GOVERNMENT OF THE DISTRICT OF COLUMBIA
DEPARTMENT OF TRANSPORTATION

MEMORANDUM

SUBJECT: Zoning Commission Case No. 15-20 – Sursum Corda

Figure 1 Proposed ROW Changes

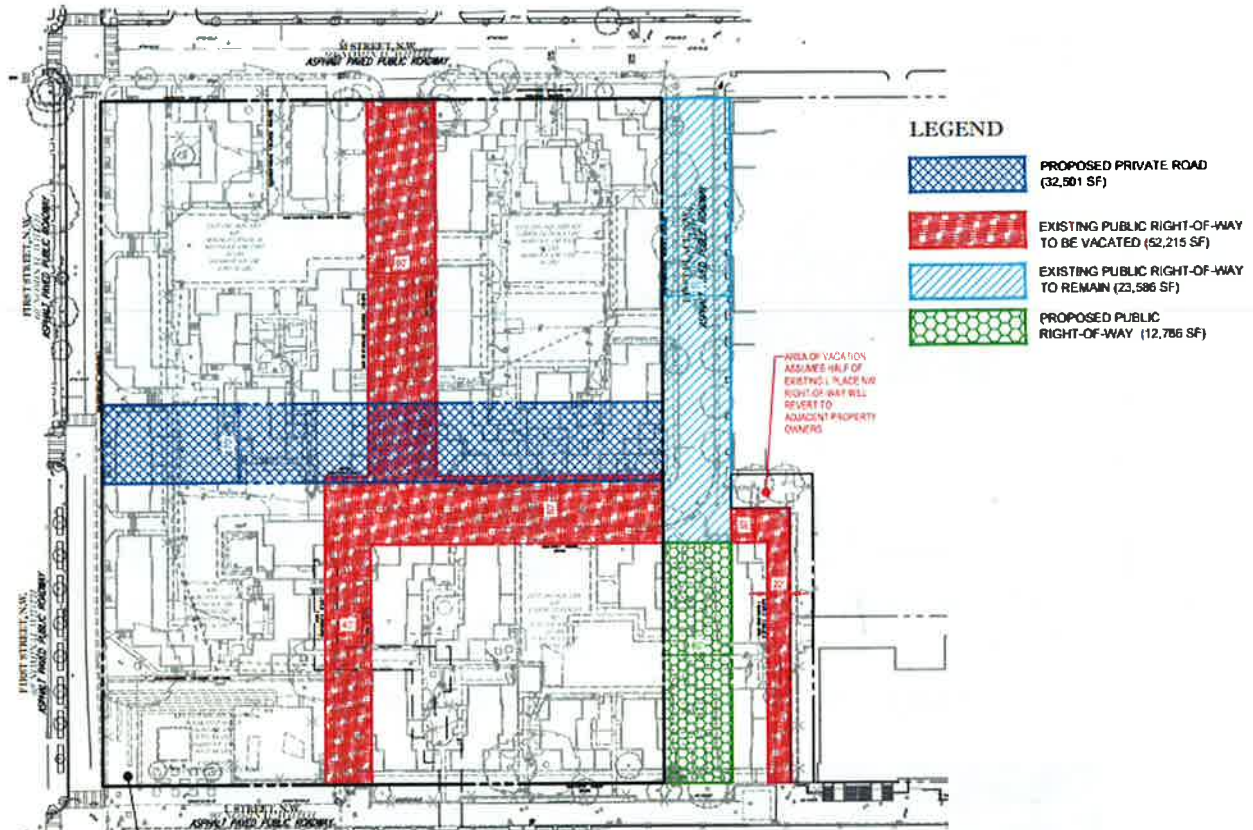
The project includes substantial changes to the internal and external road network. Changes include the closure of existing alleys, 1st Terrace through the site and a portion of 1st Place, the opening of a new segment of 1st Place to align with the existing northern alignment of the street, and the addition of a new segment of Pierce Street as a private street. Changes are shown in Figure 1.

The 1st Place opening is proposed to be 60-feet. While this dimension does not meet DDOT's 75-foot standard for new right-of-way widths, the proposed width of the new 1st Street segment matches the existing width of 1st Street and is therefore appropriate.

Pierce Street, which currently exists west of 1st Street and east of North Capitol Street, is proposed to be opened as a 70-foot wide private street and will align with the public segment of Pierce Street to the west. The existing buildings to the east of the subject site do not permit the connection of Pierce Street to the east. Pierce Street is proposed to have one lane of vehicle travel in each direction and parking on both sides of the street. While private, Pierce Street must be designed and constructed to current DDOT standards. Of note, as Pierce Street is proposed as a private street, the District will not be responsible for street maintenance, snow removal, parking enforcement, and other services the District provides to public streets. Pierce Street will be constructed as part of Phase 1.

L Street is historically a 90-foot ROW, but was narrowed in the 1960s to its present ROW width of approximately 40 feet. This narrow existing ROW does not allow for a full typical District street section, including sidewalks and tree boxes of both sides of the street, two-way traffic, and curbside parking. The ROW is further constrained to the east of the site by stairs from Mount Airy Baptist Church that project about 8-10 feet into the limited ROW. Re-establishment of a full L Street section requires the extension of the street to the south. The Severna just to the south of the subject site set back their development to preserve adequate land for the eventual re-establishment of L Street, which requires the redevelopment of the two properties to the east of the Severna. The Applicant proposes L Street as two-way operations between 1st Street and 1st Place and one-way eastbound between North Capitol Street and 1st Place, which is appropriate given the limited ROW. The Applicant will also construct the public space along L Street between 1st Place and 1st Street to current DDOT standards. To facilitate the Applicant's vision for L Street, traffic signal and pedestrian improvements are needed at the intersection of North Capitol Street & L Street. These improvements are discussed in the Mitigations section.

1st Street, too, is historically a 90-foot ROW, but was narrowed in the 1960s to its present ROW width of 60 feet. The 30-foot segment of former ROW was divided between the Sursum Corda Cooperative and the federal government under the ownership of the National Park Service (NPS). The eastern edge of the existing ROW roughly aligns with the future eastern curblineline of 1st Street, which the Applicant proposes to widen in order to facilitate two-way operations (one lane in each direction) and a parking lane on the west side of the street. This leaves no ROW on the east side of 1st Street for a typical sidewalk section, including street trees and a sidewalk. As present time, the Applicant proposes to set back their development to the historic ROW line and improve the land between the eastern curblineline and the building line to current DDOT standards.

Figure 2 – Phase 1 Site Design and Access (Source: Boggs & Partners)

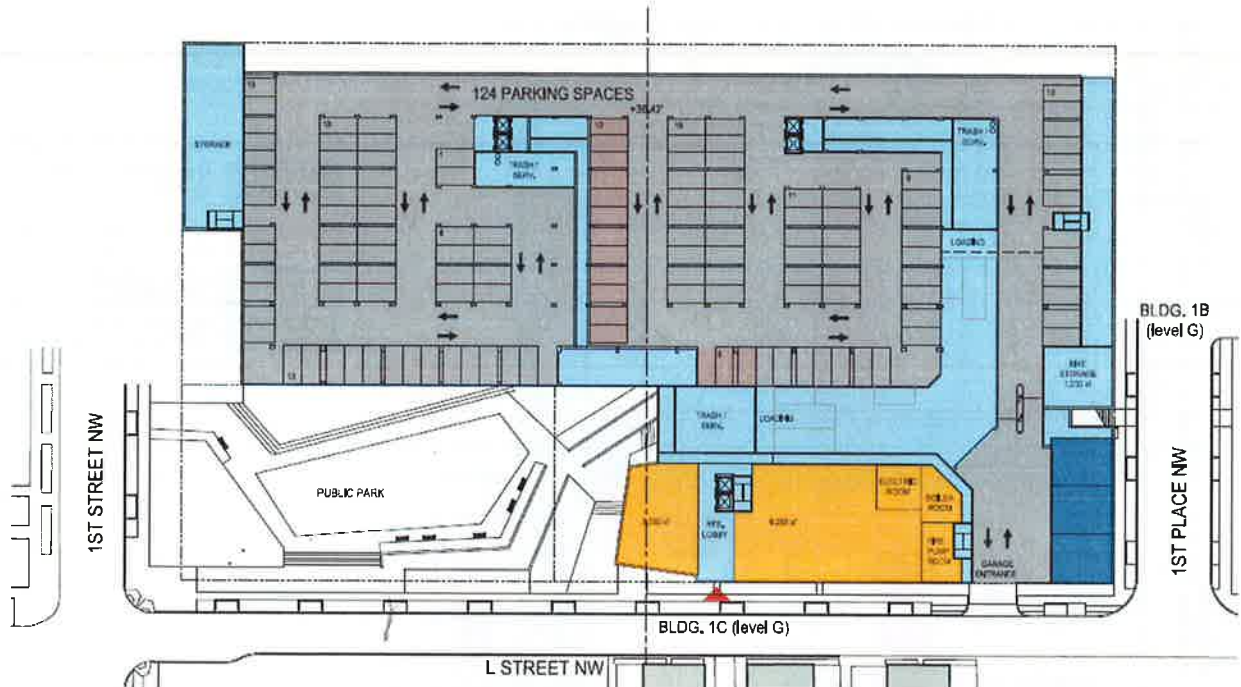
- Phase 1 features two curb cuts – one on 1st Place for vehicular access and one on L Street for combined vehicular, loading access, bicycle, and trash access both of which are consistent with DDOT standards;

The overall ground floor site plan for the project is shown in Figures 2 and 3. Phase 1 features two curb cuts – one on 1st Place for vehicular access and one on L Street for combined vehicular, loading access, bicycle, and trash access. The loading and trash facilities are designed such that they can be accessed with head-in/head-out movements from L Street consistent with DDOT standards. Phase 2 features four curb cuts – one on 1st Place for vehicular access and three on the private Pierce Street for loading and vehicular access. The two loading curb cuts are proposed to require back-in/front-out operations across the sidewalk on Pierce Street. Although Pierce Street is a private street and therefore not subject to DDOT standards that prohibit backing movements through public space, DDOT’s preference would to provide loading access with head-in/head-out movements.

For Phase 1, the loading access from L Street provides access to two loading areas – one for Buildings 1A and 1C that features two 30-foot loading berths and two 20-foot service delivery spaces and one for Building 1B that features one 30-foot loading berth and one 20-foot service delivery space. The loading facilities are connected via access corridors to each building. For Phase 2, the two loading areas accessed from Pierce Street will each contain one 30-foot loading berth and one 20-foot service delivery space.

The zoning regulations require that each of the five separate buildings provide one 55-foot loading berth and one 20-foot service delivery space. The Applicant instead proposes five total 30-foot loading berths and five total service delivery spaces. DDOT finds the 30-foot berths are sufficient to accommodate the loading needs of the proposed residential unit size and mix. Zoning regulations do not require loading facilities for the non-residential uses. In the event that larger trucks need to access the site to serve either the residential or non-residential uses, Emergency No Parking signs are available from DDOT.

Figure 3 – Phase 2 Site Design and Access (Source: Boggs & Partners)

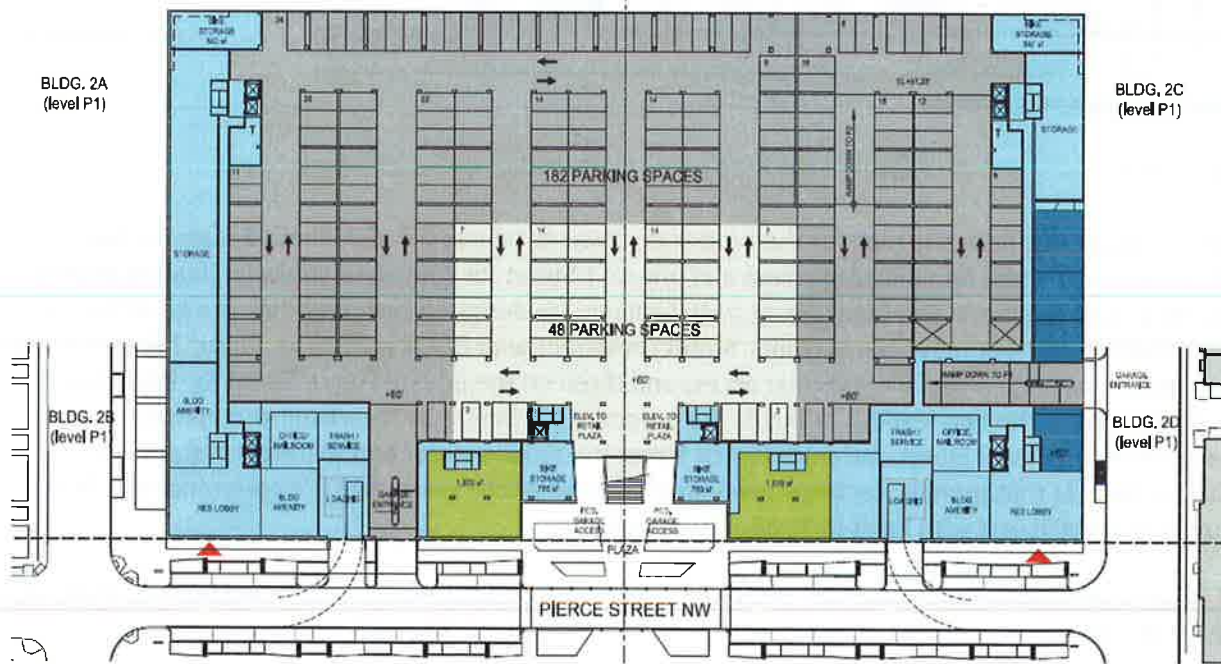
- Phase 2 features four curb cuts – one on 1st Place for vehicular access and three on the private Pierce Street for loading and vehicular access. All three curb cuts proposed on the private Pierce Street are inconsistent with DDOT standards due to either close proximity to each other or back in loading operations; and
